ADDENDUM NO. 1

PROJECT NAME: Wick Alumni Center Life Safety & HVAC Improvements
UNL PROJECT NUMBER: C120P021
BID INVITATION NUMBER: 2222-13-7200

CONSULTANT: Farris Engineering
ADDRESS: 818 P Street, Suite 100

DATE OF ISSUANCE: September 3, 2013
DATE OF BID OPENING: September 18, 2013

SHEET TITLE
LARGE-SCALE
HVAC PIPING
AND PLUMBING
PLANS

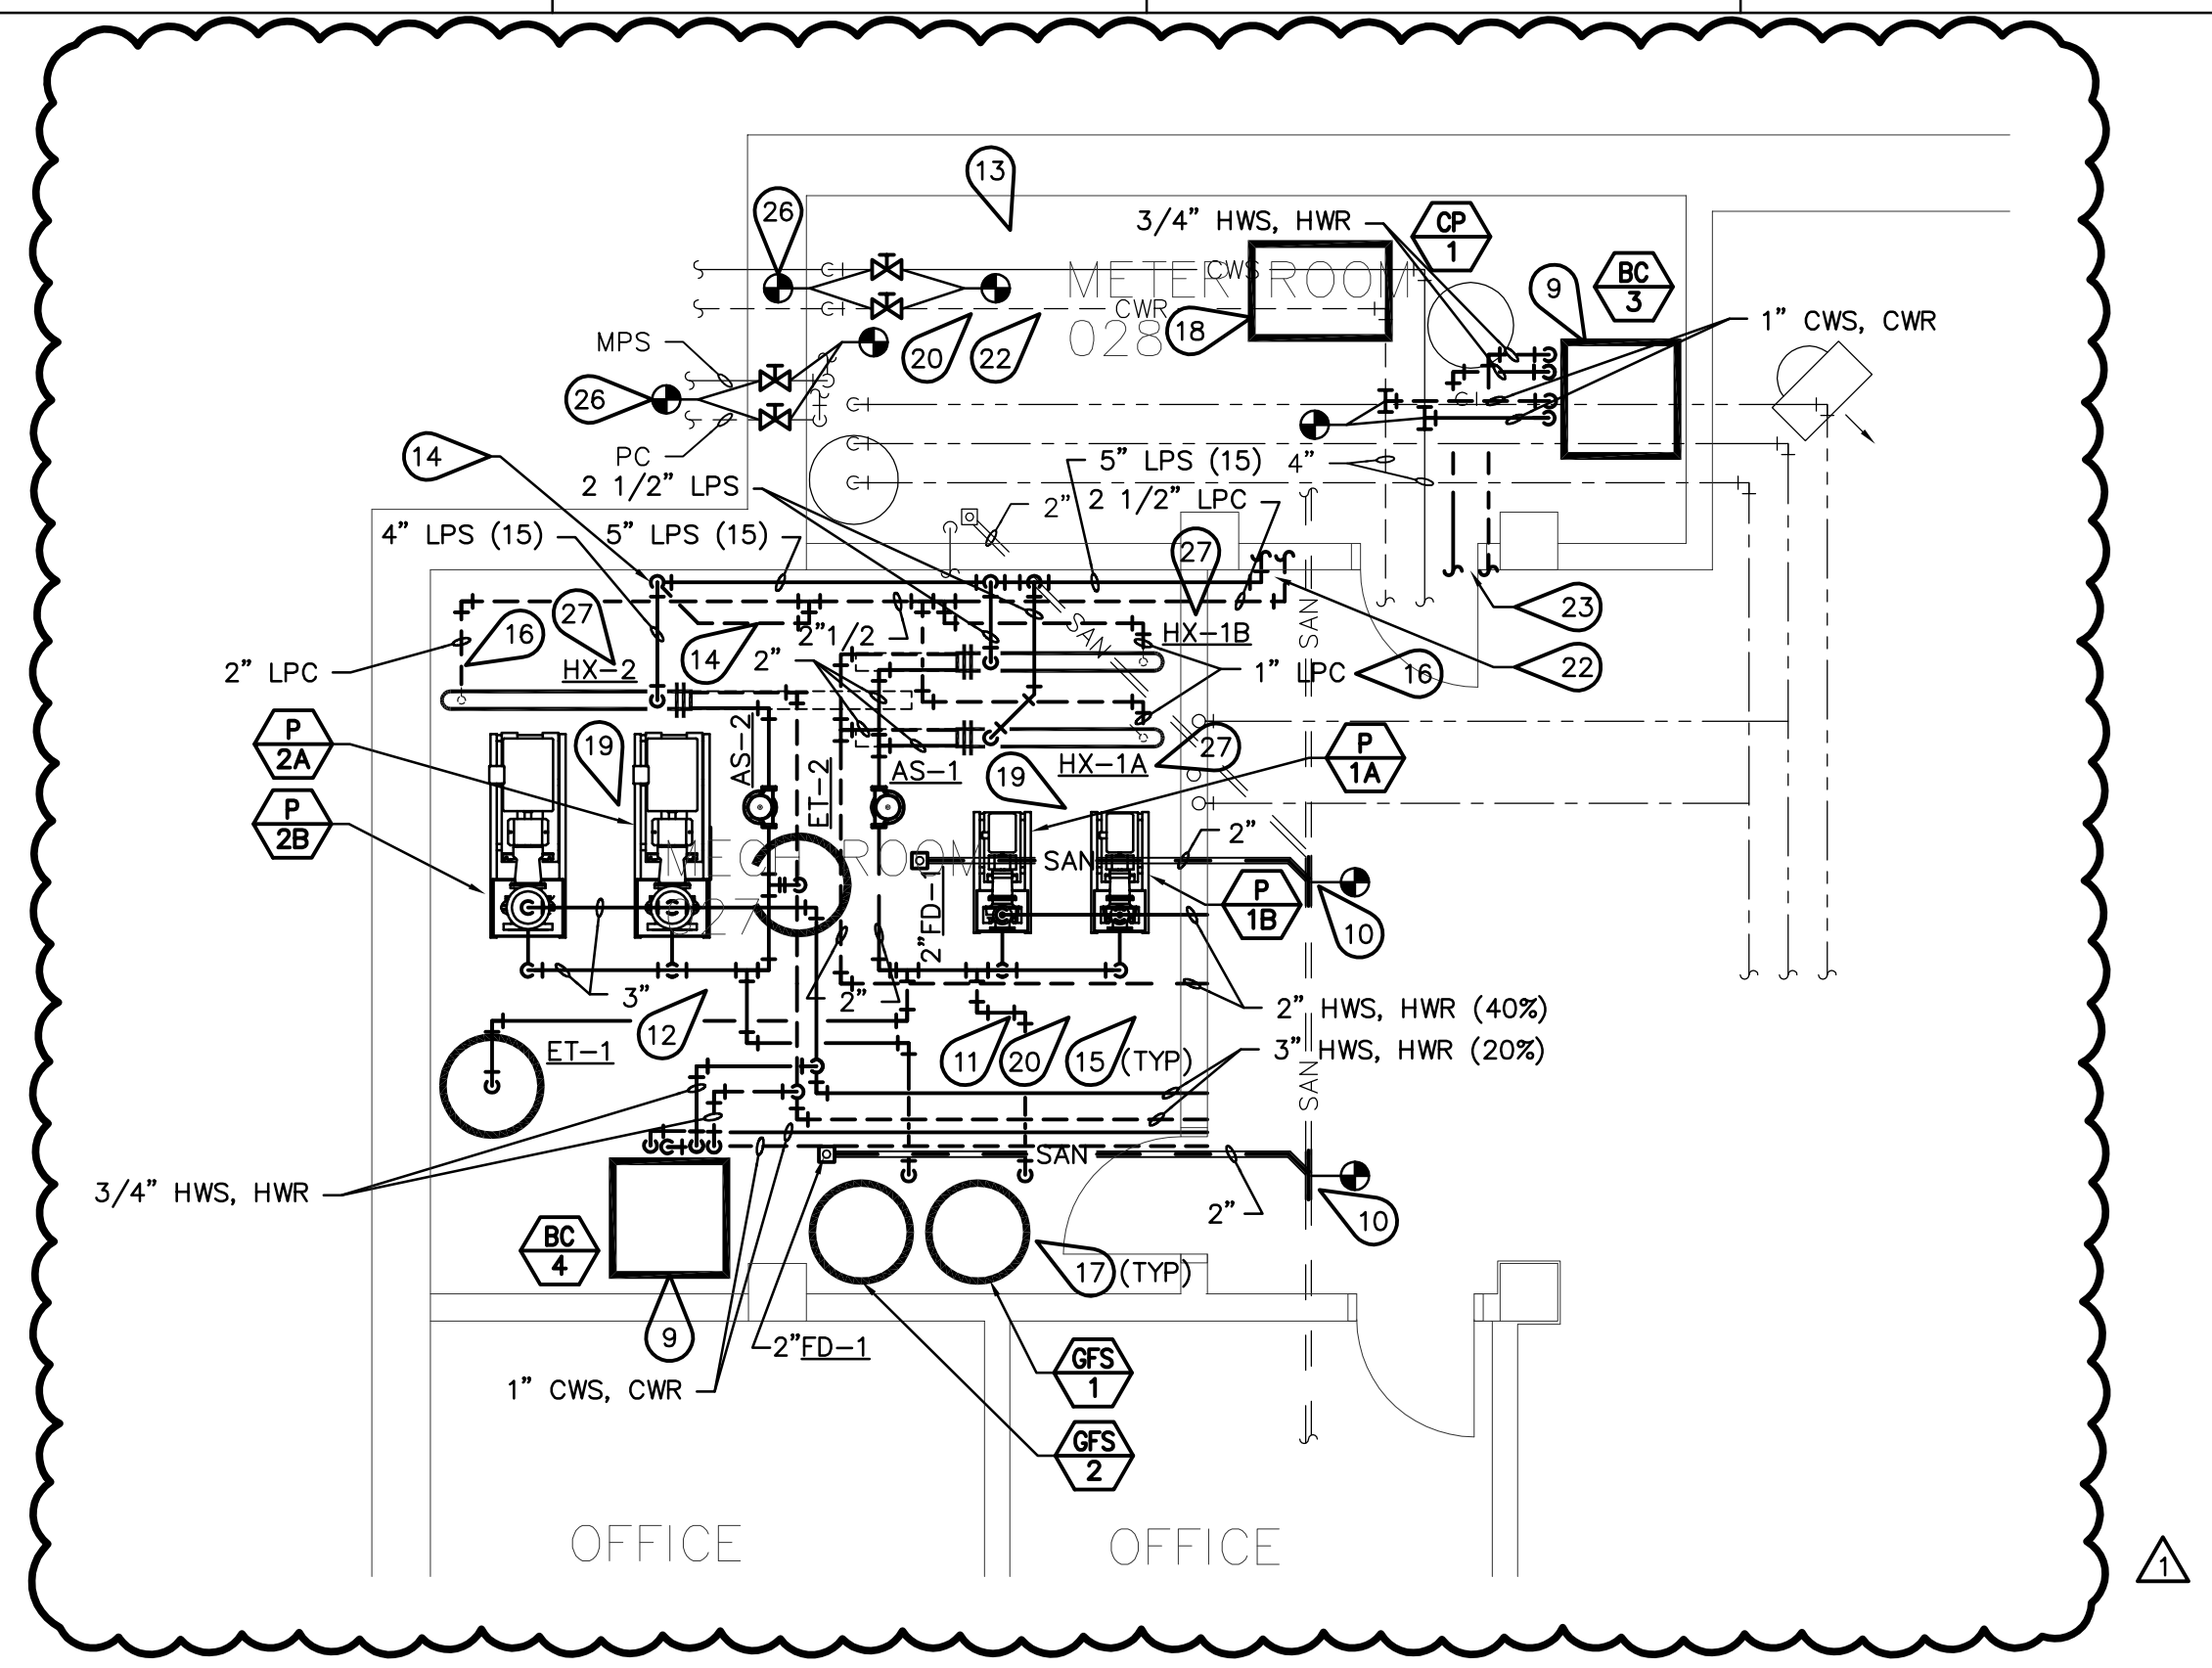
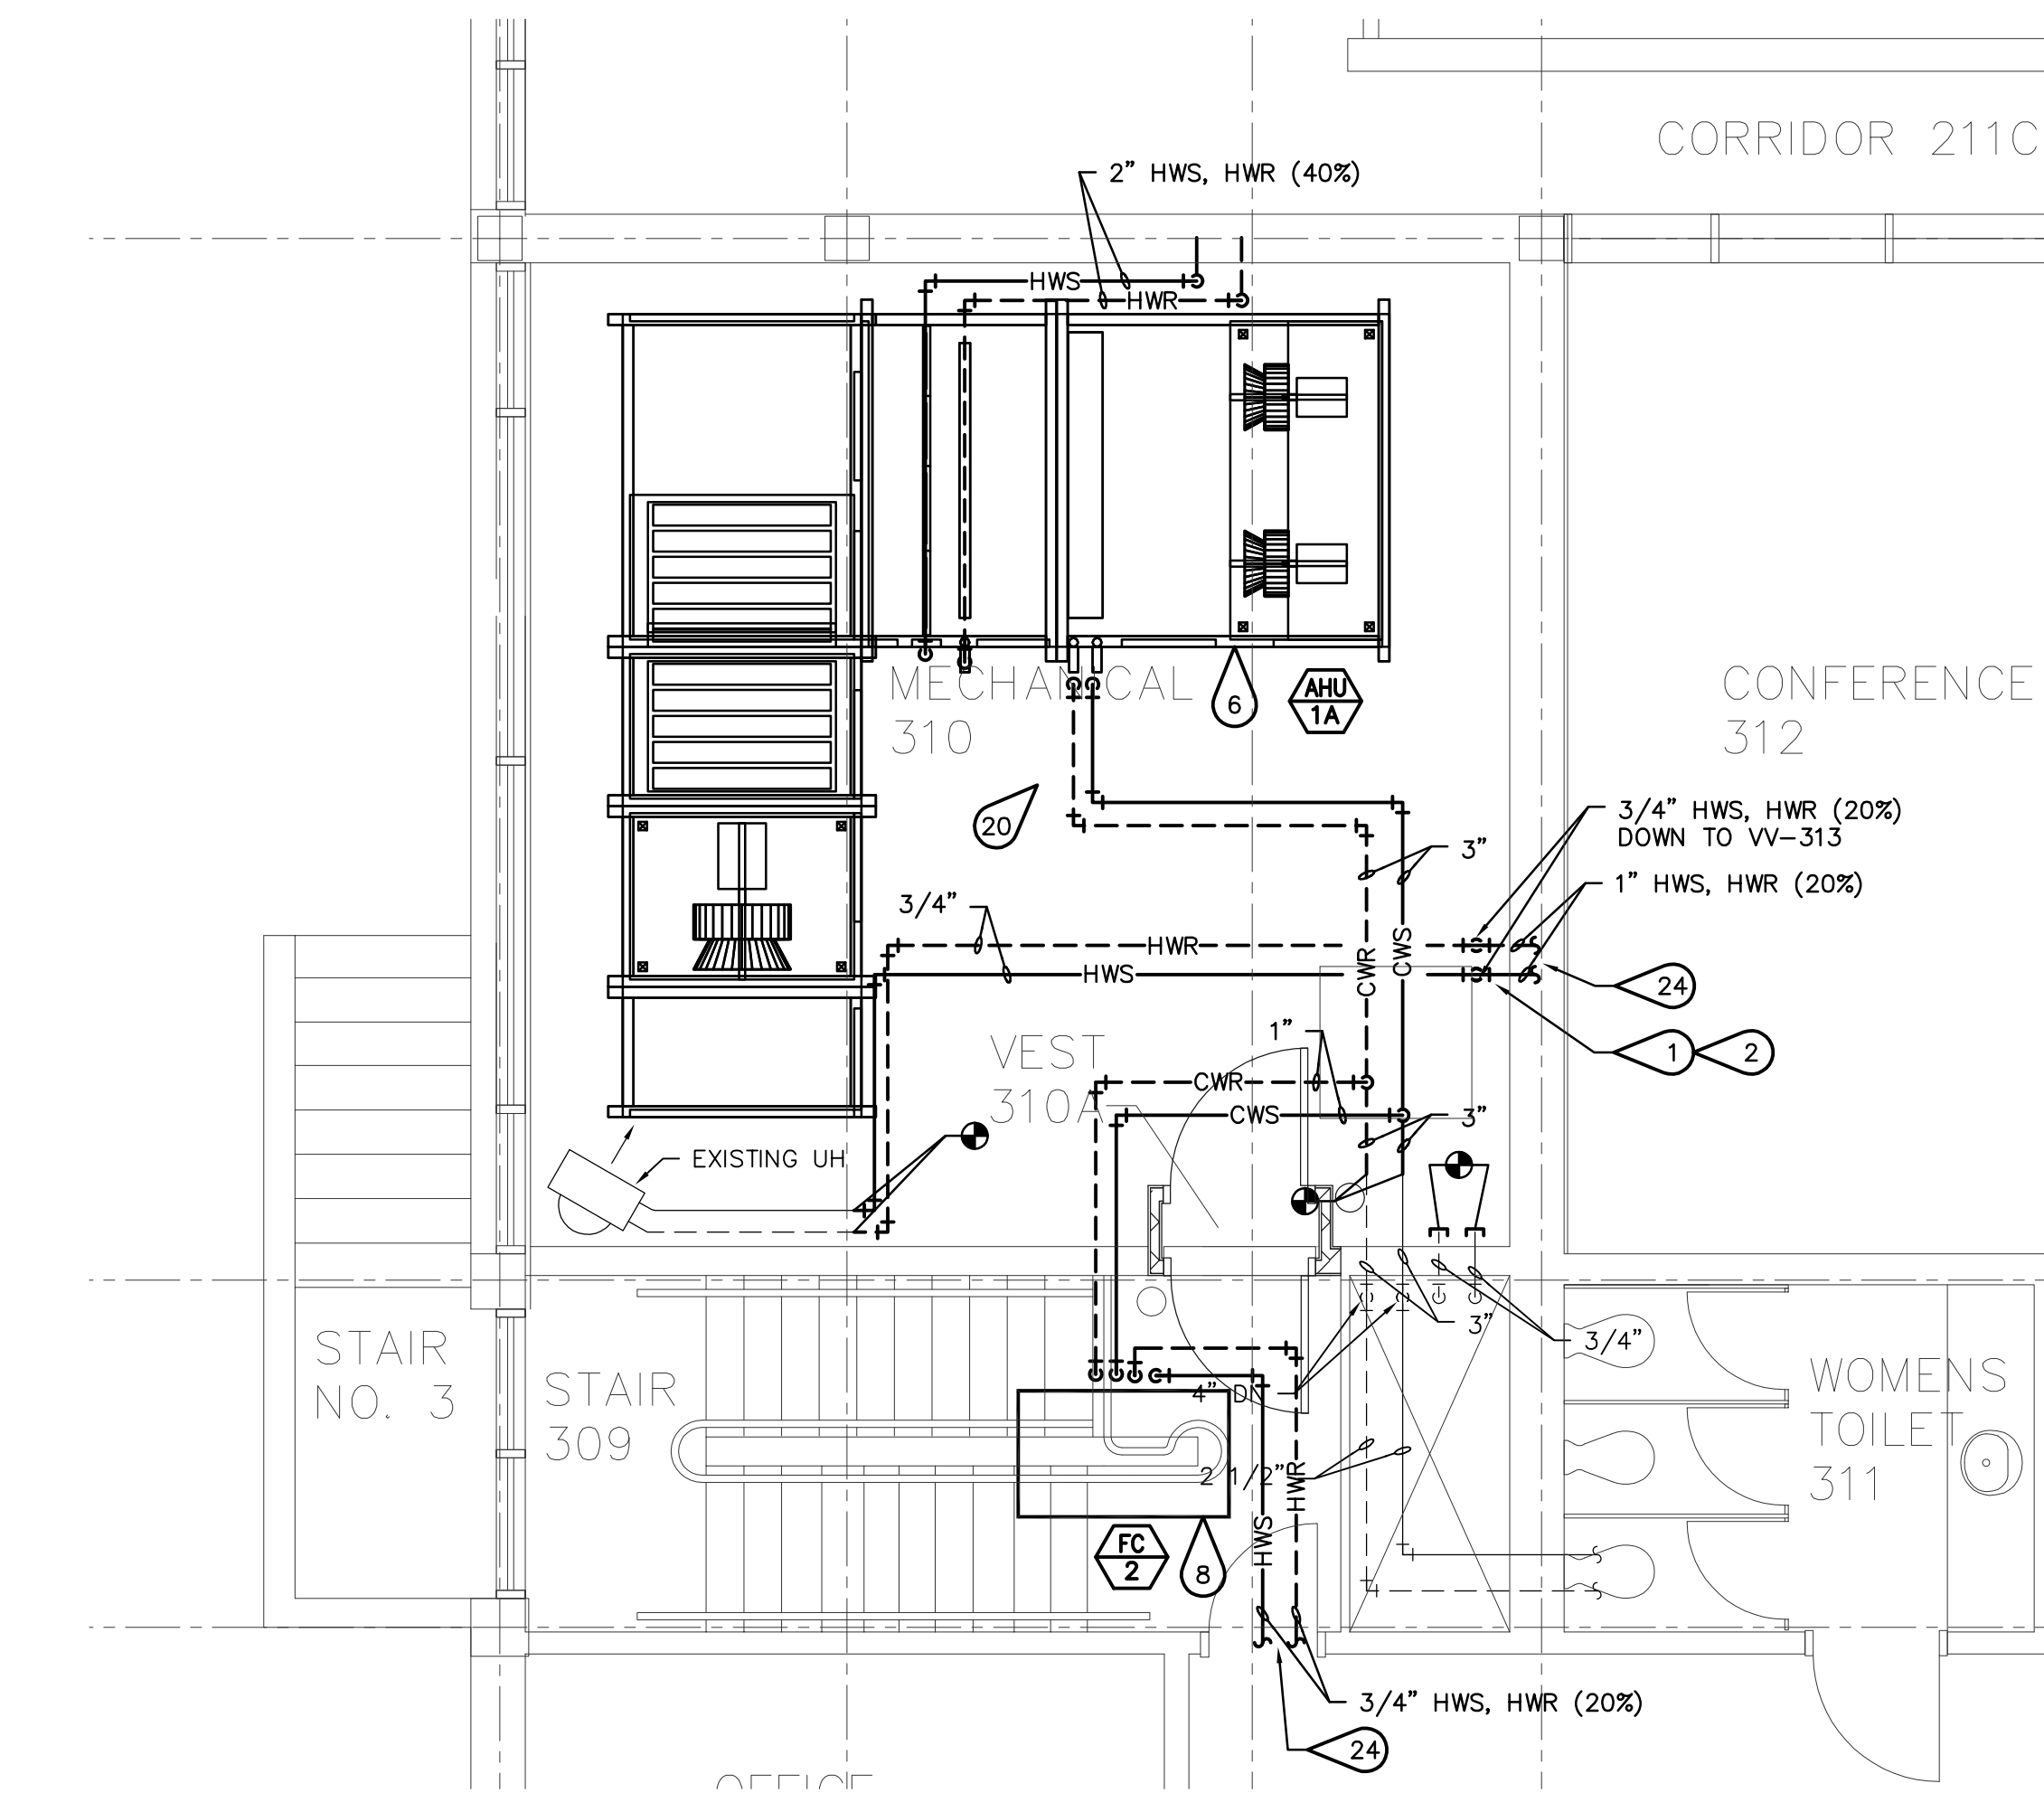
7. SHEET A1-3, MECHANICAL 401 RENOVATION PLAN: At the north wall of Mechanical Room 401, add the following note: “See Sheet M2-3 ‘Mechanical 401 HVAC Piping Plan’ for exterior pipe penetration requiring sealant”.

12. SHEET M2-3, LARGE-SCALE HVAC PIPING AND PLUMBING PLANS:
 - A. This sheet has been reissued in its entirety as a part of Addendum No.1.
 - B. "MECHANICAL ROOMS 027, 028 HVAC PIPING AND PLUMBING PLAN" has been revised.

- C. Mechanical Keynote #27 has been revised.
13. SHEET MD2-3, LARGE-SCALE HVAC PIPING AND PLUMBING DEMOLITION PLANS:
 - A. This sheet has been reissued in its entirety as a part of Addendum No.1.
